ADA site access relocation

FORM P3: ADMINISTRATIVE DECISIONS AND MINOR AMENDMENTS**_ ARCHAEOLOGICAL CERTIFICATE**

**RE: Minor Amendment- 2110 Carlisle Boulevard NE
Planning case file # PR-2019-002677**

PROJECT TITLE: CARLISLE CROSSING
2100 CARLISLE BLVD NE
ALBUQUERQUE, NEW MEXICO

1 Relocate Handicap Ramp

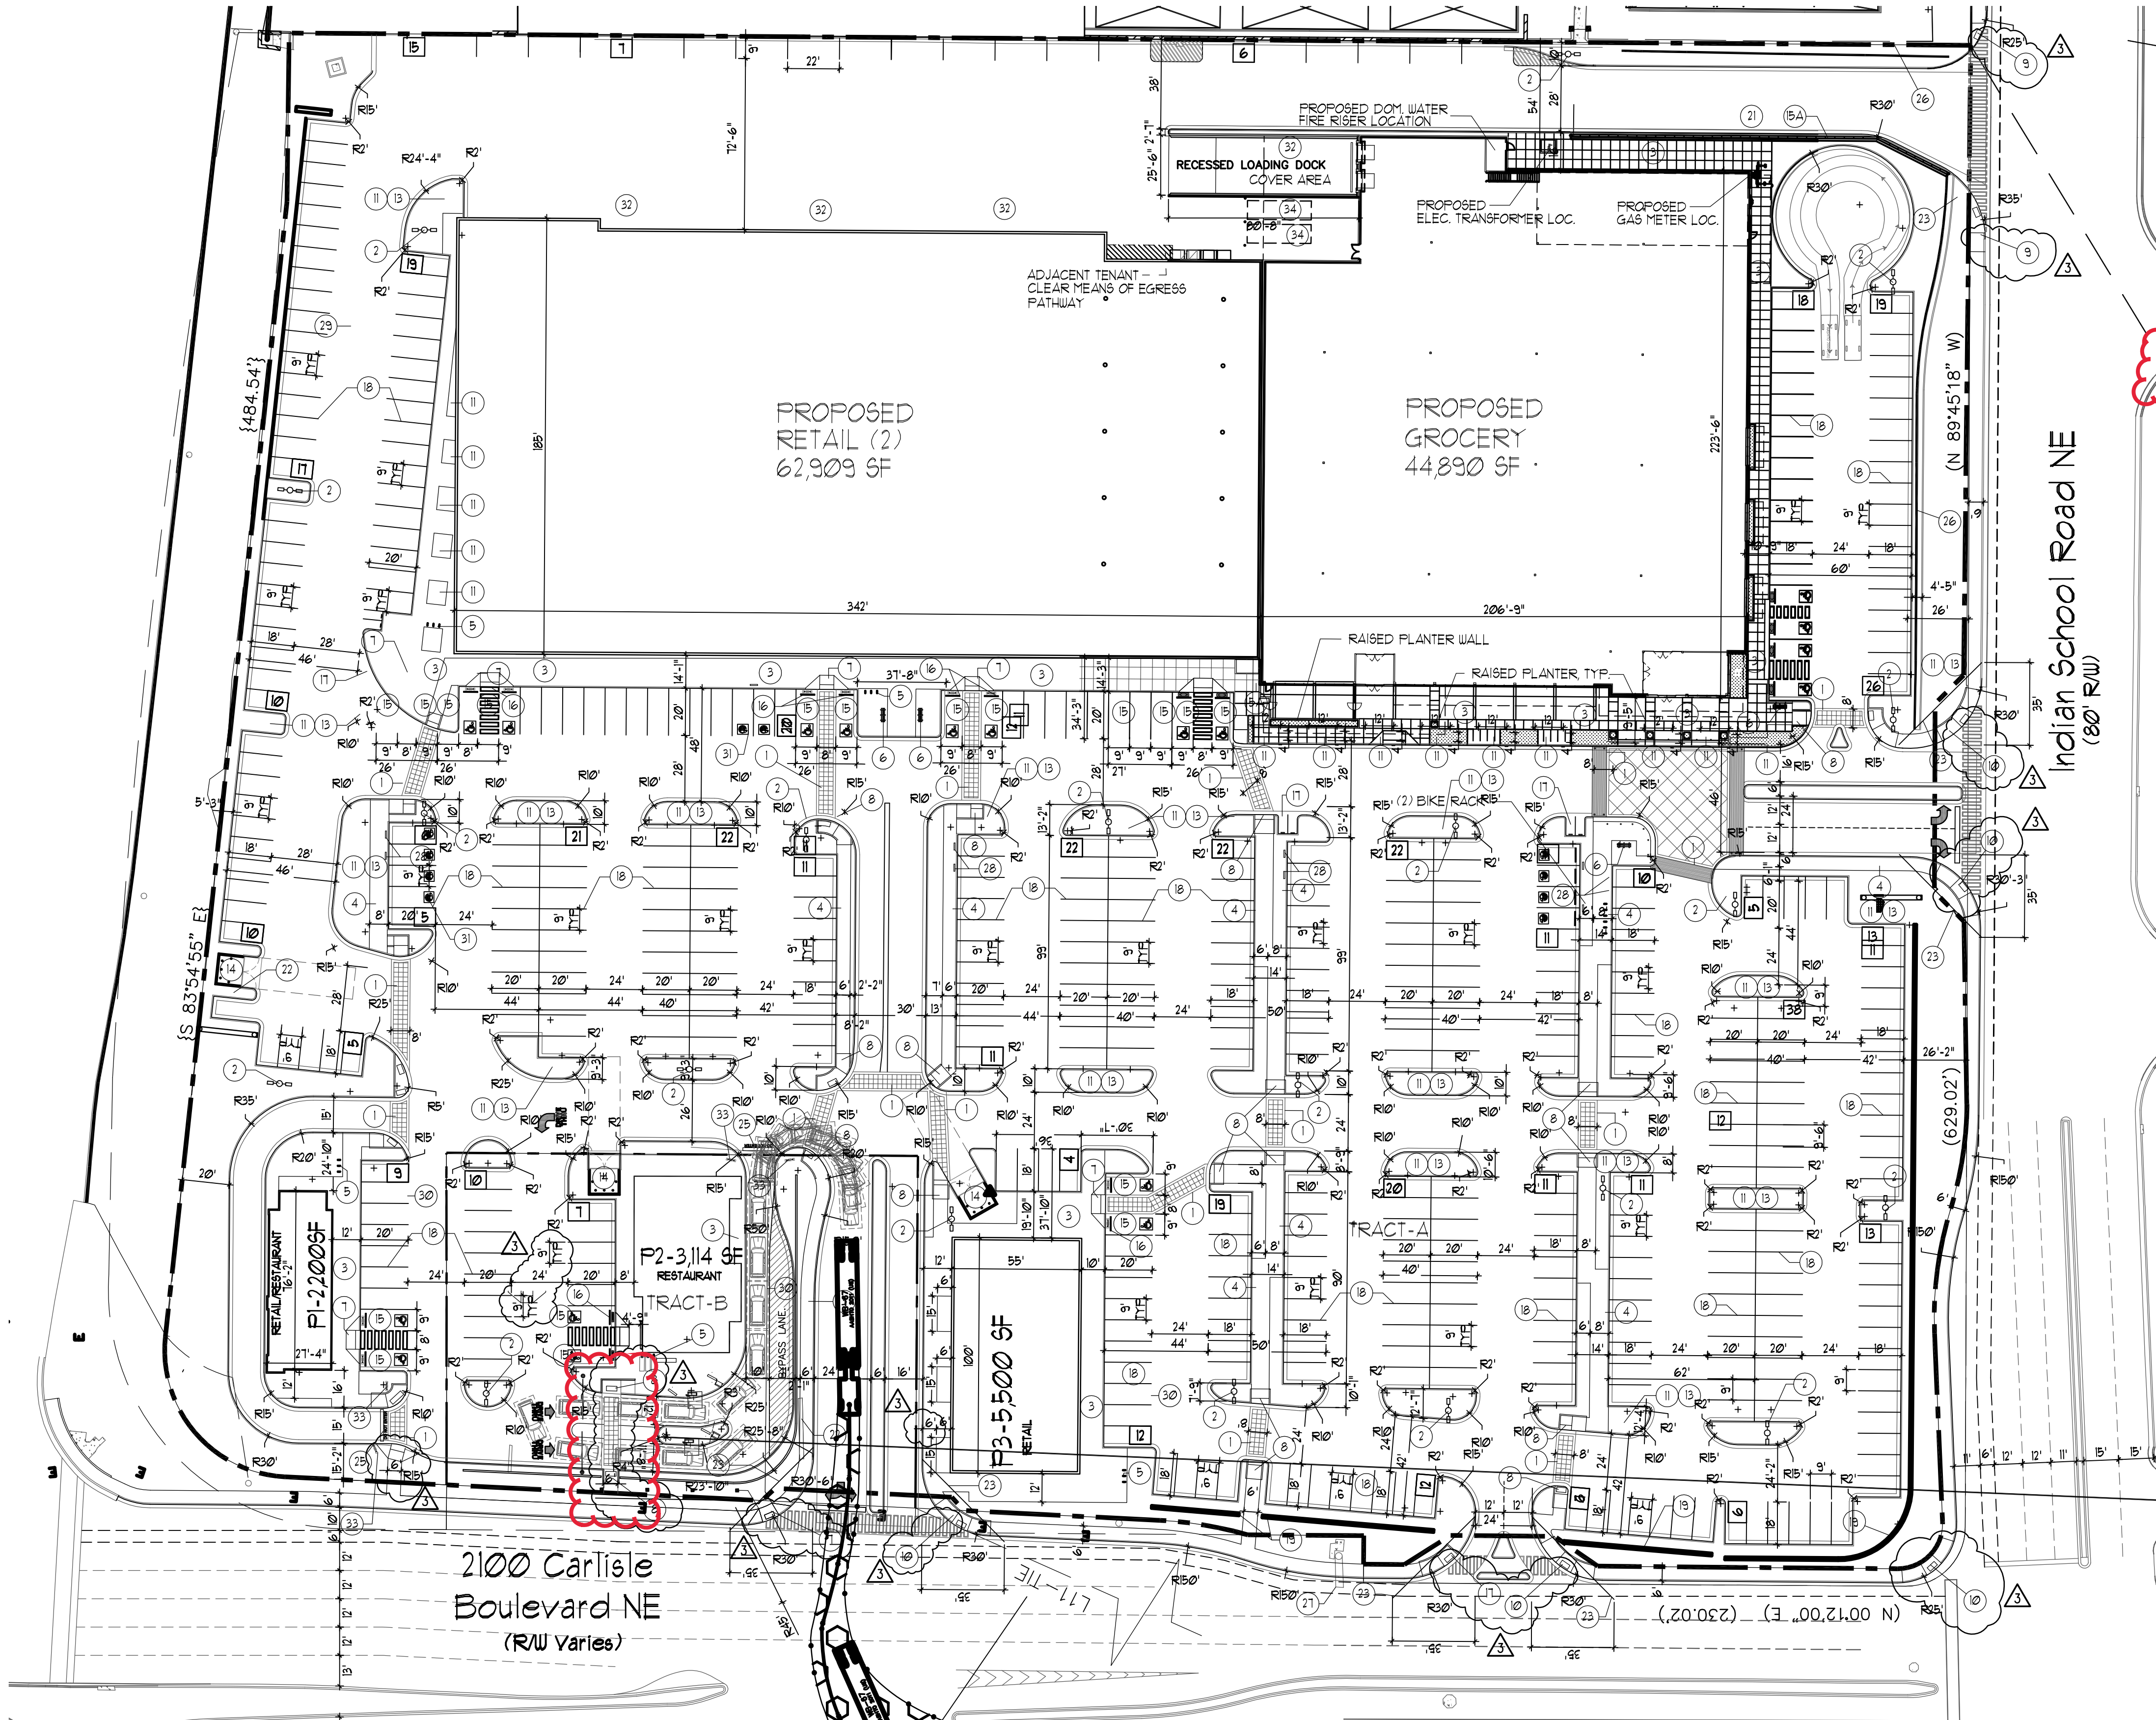
The requested changes are to the area of the northwest corner of the site and are circled in red and noted on the originally approved **Carlisle Crossing- Site Plan for Building Permit**. It is the applicant's intent to eliminate the handicap ramp that connects to the public sidewalk on Carlisle Boulevard because it is not constructable. The ramp is shown on the approved plan directly west of the drive-thru and corresponds to keyed note #8 on sheet BP-1. The revised ramp location are shown on the proposed Site Plan for Building Permit and coincide with delta revisions #4 and #5 on sheet BP-1. Due to the significant grade change between the public sidewalk and the existing restaurant site of approximately 3 to 4 feet, it is not feasible to construct a ramp where shown on the approved site plan. The accessible

access route is proposed to be relocated to the main entrance to the shopping center adjacent to the restaurant. We believe that the proposed changes to the plan are in harmony and consistent with the originally approved Site Development Plan for Building Permit because it still provides a handicap accessible route from the public way. Furthermore, the proposed changes are not in conflict with any of the regulations or other requirements of the plan.

SITE PLAN FOR BUILDING PERMIT

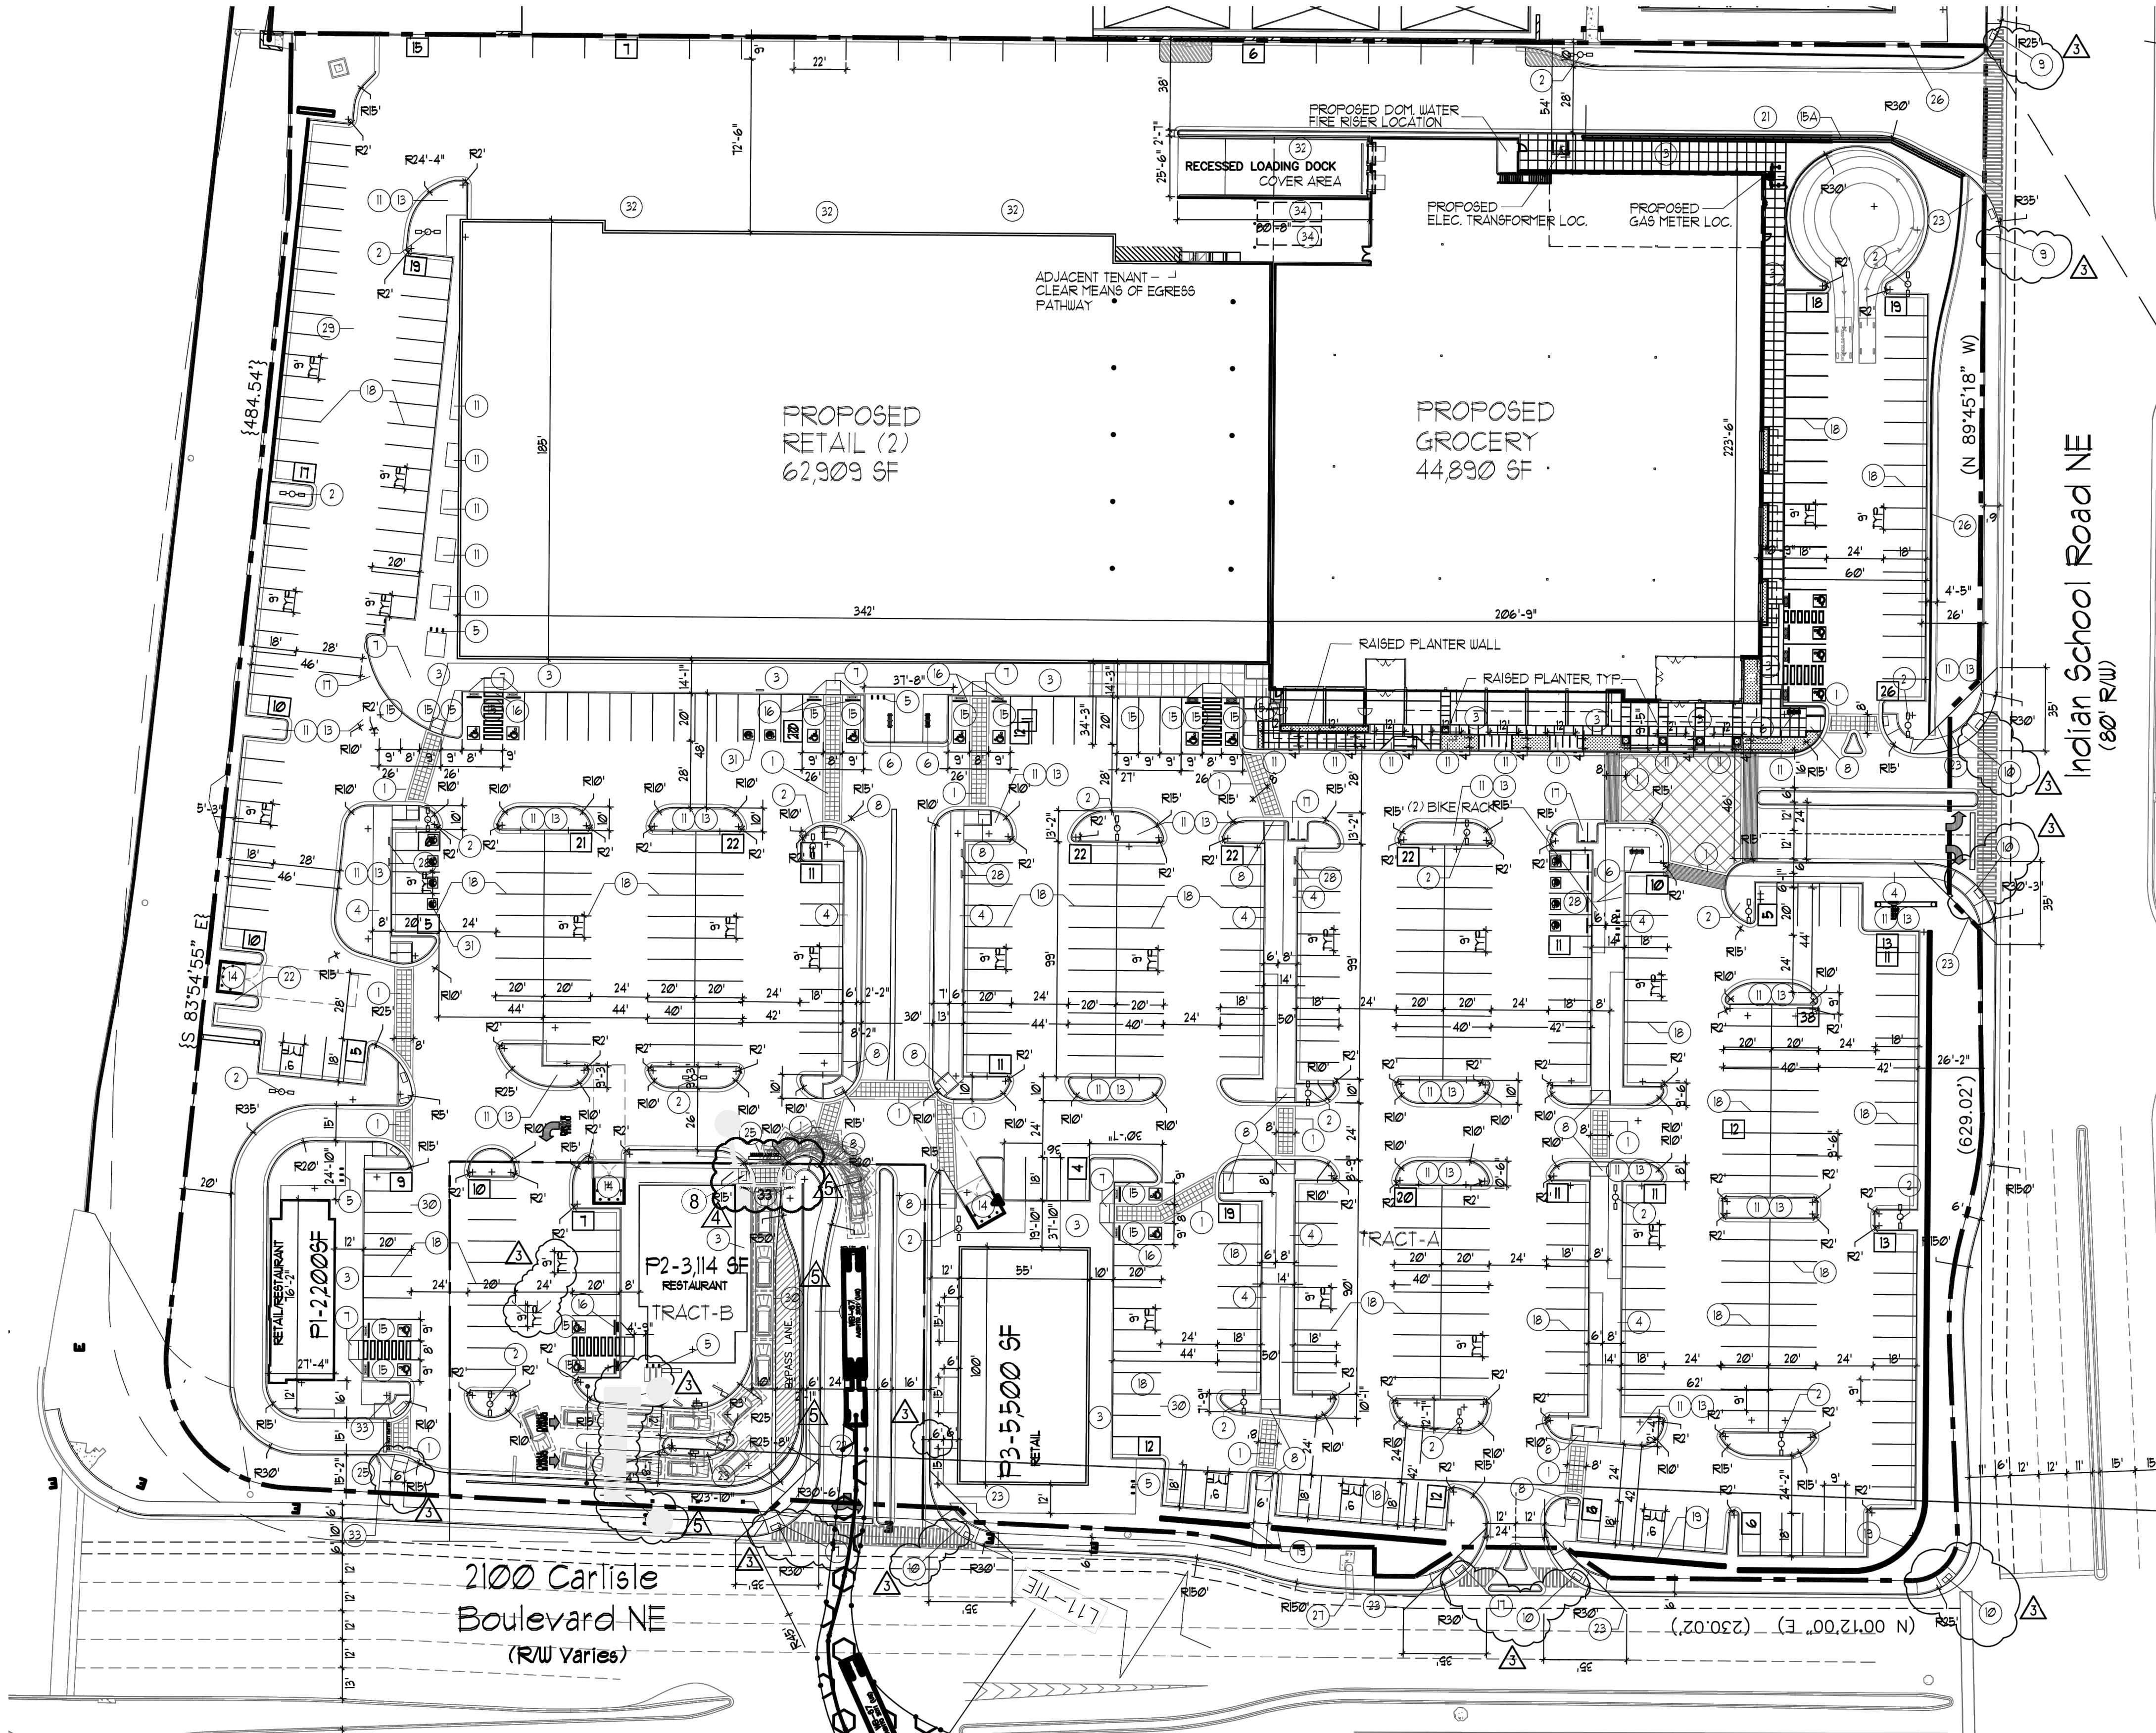
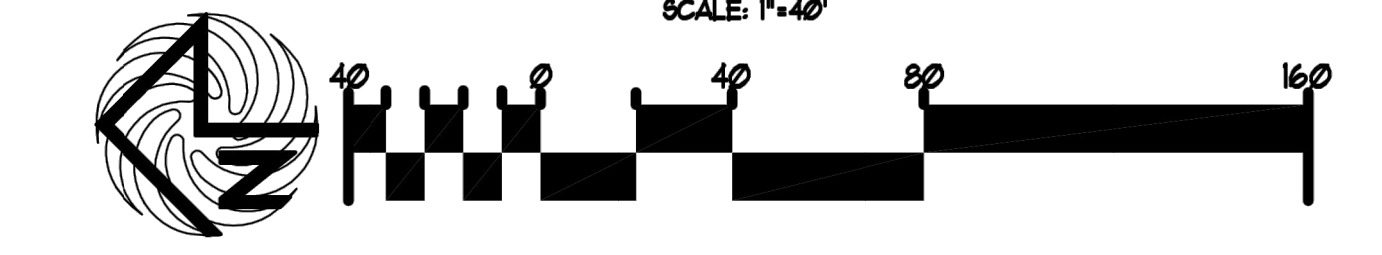
- △ MOVE LOCATION OF ADA SITE ACCESS TO LEVEL GRADE PER KEYED NOTE 8
- △ EXISTING ADA PATH WE CONNECT TO WITH THIS AA
